Access Compliance Report

Public Rights-of-Way (Curb Ramps)

Intersection ID: 54423	Main Street: BLARNEY RIDGE DR	Cross Street: KILKENNY DR	Location:	N
ADA ID: A664A28E368F	Ramp Type: Directional	Initial Pass/Fail: Fail	Overall Compliance: No	Severity Score: 1.25

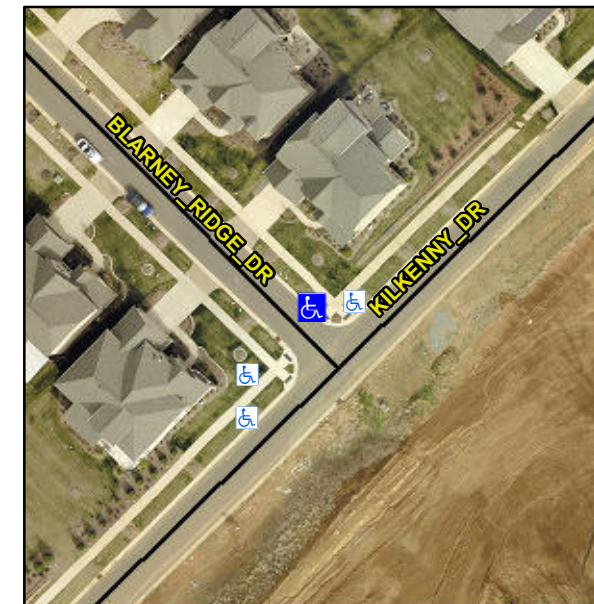
Surveyor Notes:

N/A

PROW/ADA:

R304.5.3

Possible Solutions:

Remove & Replace Entire Ramp.
